Town of Washington Inland Wetlands Commission

APPLICATION TO MODIFY AN APPROVED PERMIT

1. Address of Permitted Activity: 236 NETTLETON Hollow RD
2. Name of Property Owner: JOSEPH BARALTA
3. Granted Permit # IW-20-07 Approval Date: 3-11-20 Granted for: 5 years
4. Mailing Address of Property Owner: 236 NETTLETON Hollow RD
WASHINGTON, CT 06793
5. Property Owner's Phone Number: 860-619-0226 Email: JOSEPH.BARALTA@GMAIL.COM
6. Authorized Agent: MATTHEW J. GIRONDA, P.E. Letter of Authorization? Yes No
7. Agent's Phone Number: 914-277-5805 EXT. 314 Email: M.GIRONDA@BIBBOASSOCIATES.COM
8. Brief Discussion of Permitted Activity(s): MINOR ADDITIONS TO EXISTING DWELLING AND CONSTRUCTION OF NEW FLAGSTONE PATIO WITHIN 100' REVIEW AREA.

SITE PLAN		DATE:	02-04-20
BARATTA		SCALE:	1" = 20'
236 NETTLETON HOLLOW ROAD TOWN OF WASHINGTON, CT 06793		FILE:	10-11
		DSGN / CHK:	MG/TA
BIBBO ASSOCIATES, LLP		DRN. BY:	DK
293 ROUTE 100 SUITE 203 SOMERS, NEW YORK 10589 TEL. 914 277 5805		SHT NO.:	1 OF 4
SP-1		DWG NO.:

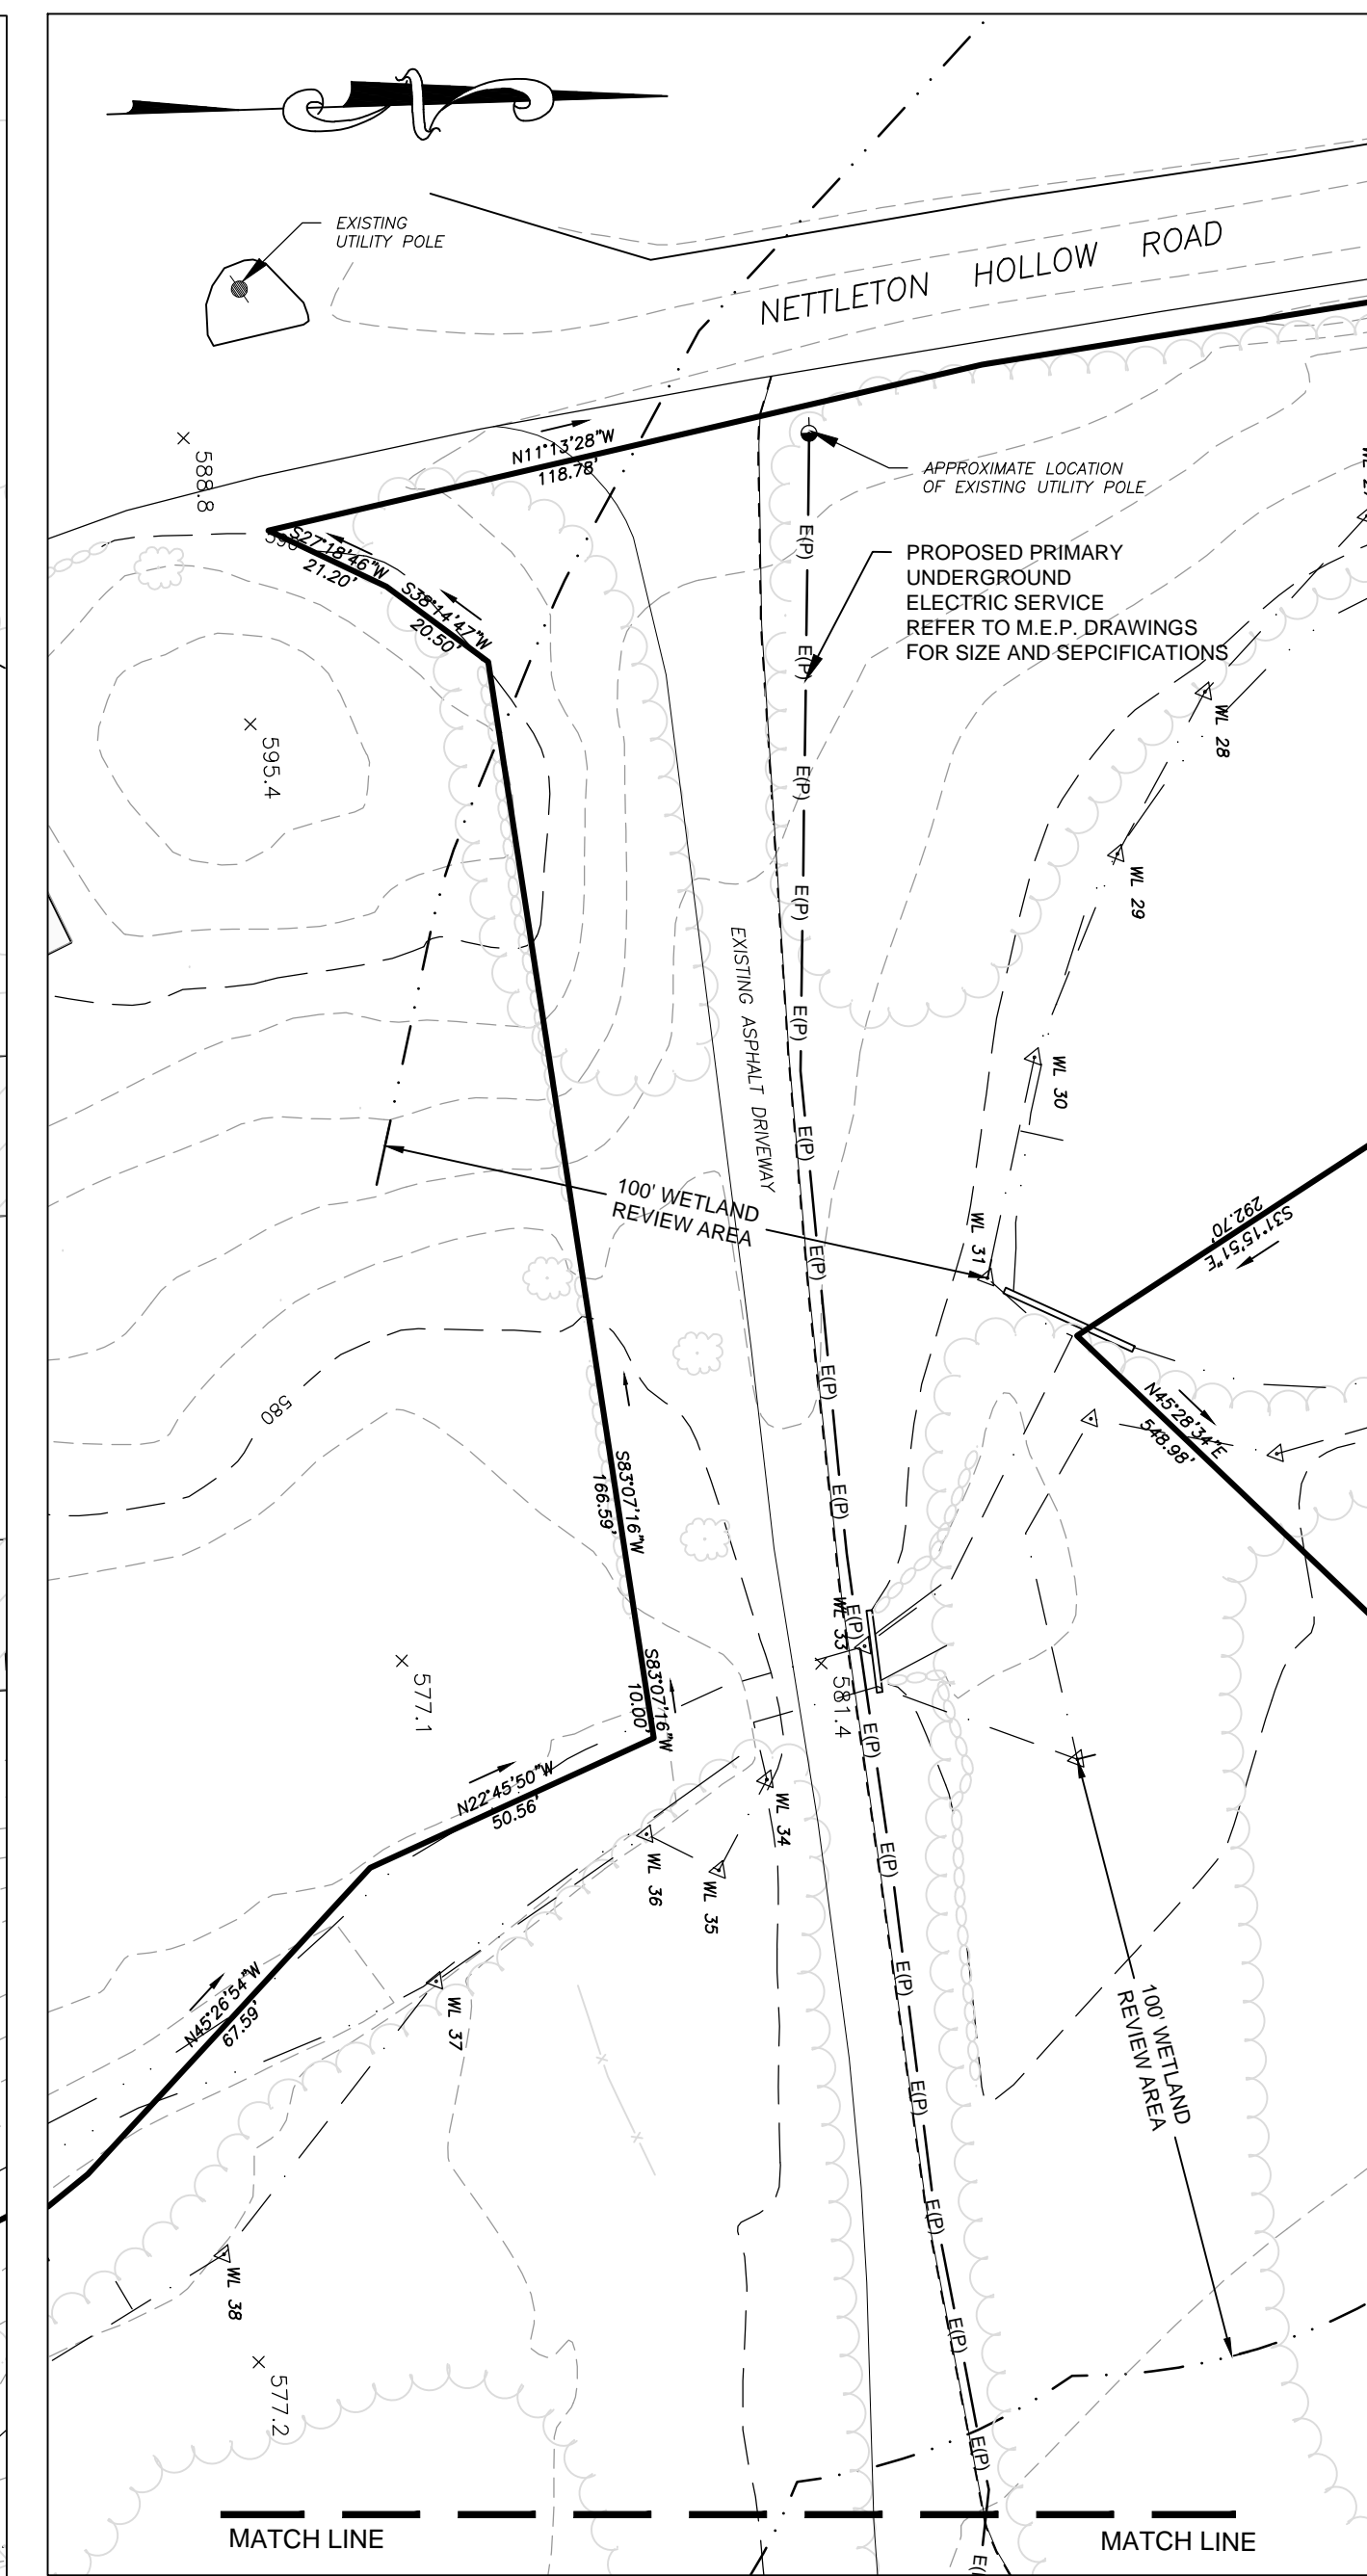
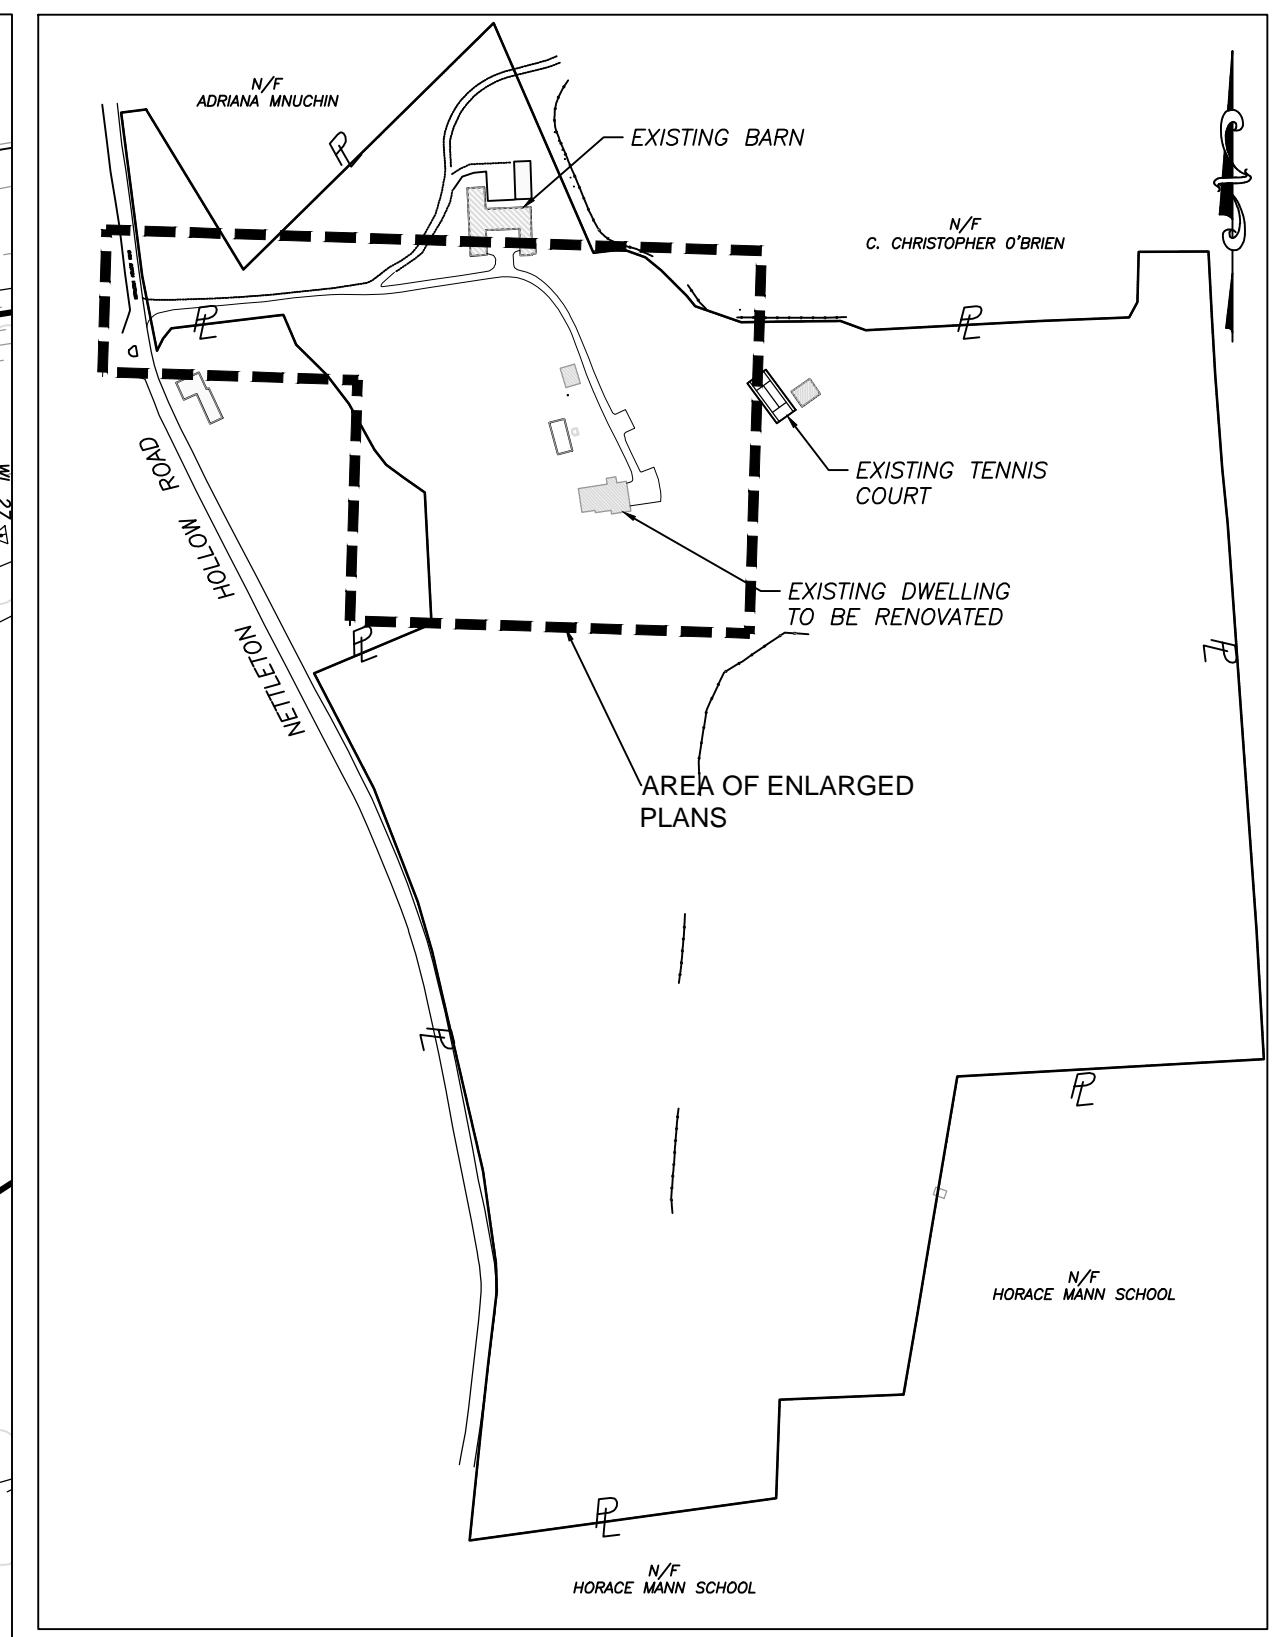
The scope of the project has been revised since the previous approval, the applicant has instead decided to complete interior renovations and construct 2 small additions to the existing dwelling. Relative to the previous approval, this modification will result in a reduction of proposed land disturbance and impervious surface within the wetland review area.

The proposed house will be served by the existing Sewage Disposal System and well. Please note the existing SDS was determined to be of adequate capacity based on as-built records obtained from the town health department.
